Access Compliance Report

Public Rights-of-Way

Intersection ID: 10829	Main Street: E_34TH_ST	Cross Street: HOLT_ST	Location: W
ADA ID: 3479C0353D3A	Ramp Type: PerpDiag	Initial Pass/Fail: Fail	Overall Compliance: No
		Severity Score: 12.5

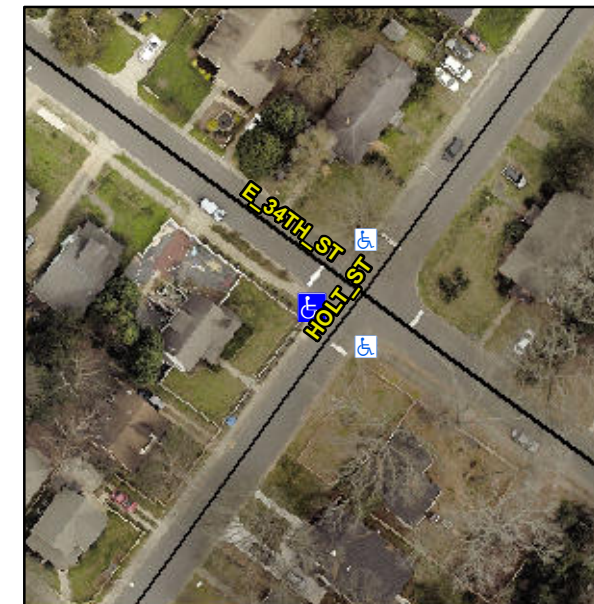
Not Found, R304.2.2

Compliance	Description	Data	Compliance	Description	Data
N/A	Ramp Length (in)	54.5	No	Ramp Slope (%)	9.1
Yes	Ramp Width (in)	48.0	Yes	Ramp XSlope (%)	1.8
N/A	Flare Type LT	N/A	N/A	Flare Type RT	N/A
N/A	Flare Slope LT (%)	N/A	N/A	Flare Slope RT (%)	N/A
N/A	Flare Traversable LT?	N/A	N/A	Flare Traversable RT?	N/A
N/A	Landing Length (in)	N/A	N/A	DWS Provided?	N/A
N/A	Landing Width (in)	N/A	N/A	DWS Contrast?	N/A
N/A	Landing Slope (%)	N/A	N/A	DWS Length (in)	N/A
N/A	Landing X Slope (%)	N/A	N/A	DWS Full Width?	N/A
N/A	Landing Curb? (Y/N)	N/A	N/A	DWS Offset (in)	N/A
N/A	Shared Landing?	N/A			
N/A	Gutter Ponding?	N/A	N/A	Gutter Slope (%)	N/A
N/A	Gutter Lip Ht (in)	N/A	N/A	Gutter X Slope (%)	N/A
N/A	Painted X Walk1?	No	N/A	Painted X Walk2?	No
	X Walk 1 Direction	To SE		X Walk 2 Direction	To NE
N/A	X Walk 1 Width (in)	N/A	N/A	X Walk 2 Width (in)	N/A
	X Walk 1 Slope (%)	5.0		X Walk 2 Slope (%)	0.3
	X Walk 1 X Slope (%)	2.4		X Walk 2 X Slope (%)	3.2

Remove & Replace Curb Ramp With Two New Directional Ramps or Equivalent.
